NOTICE OF DECISION

CLASS 3 SITE PLAN REVIEW / CLASS 1 DESIGN REVIEW CASE NO.: SPR-DR23-21

SUMMARY: Proposed 24-unit multiple family residential development with associated common open space and site improvements.

LOCATION: 1341 Waller St SE, Salem OR 97302

Following please find a marked-up map (*figure 2*) and list of protection measures we recommend you take throughout the construction process to ensure the second oak tree (32" diameter) will be preserved and protected.

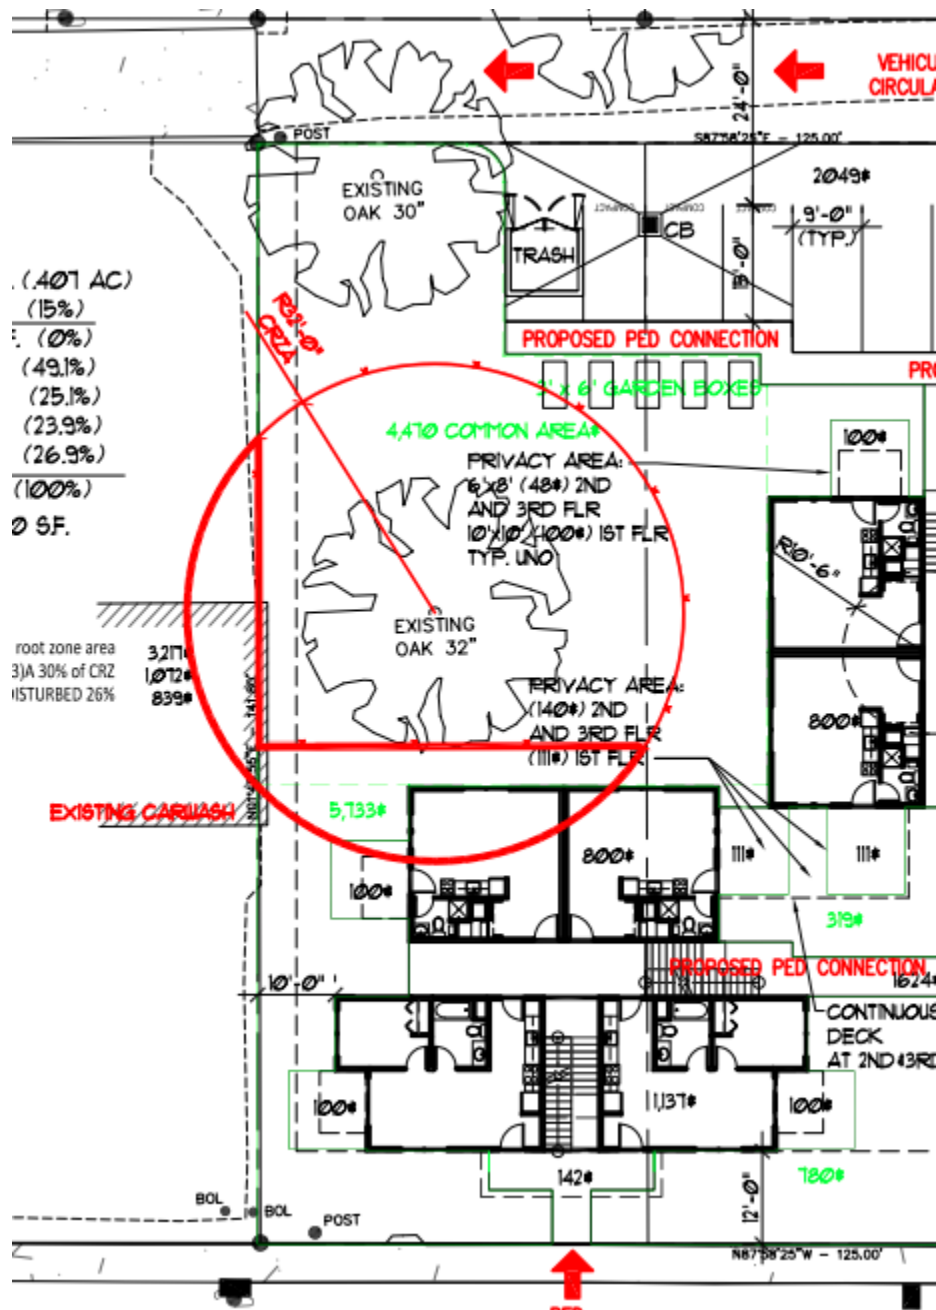
- Take care to not wound or break tree trunks or branches through contact with vehicles and heavy equipment.
- SPECIFIC to oak tree 32" circled in Figure 2. The west side of the tree has been in close proximity to the existing building and concrete, and appears to have adapted. The south side of the tree will be somewhat impacted in the construction zone however we are confident protection fencing around the tree, at approximately 74% coverage of the critical root zone, will not adversely affect or damage the health of the tree.

- Condition 6:** Protective fencing for the 32-inch oak on the property shall be provided that encompasses 74 percent of the critical root zone of the tree as identified in the arborist report included as Attachment I to this decision. The protective fencing shall remain in place until issuance of certificate of occupancy for the development and all recommended protection measures identified in the arborist report shall be followed.
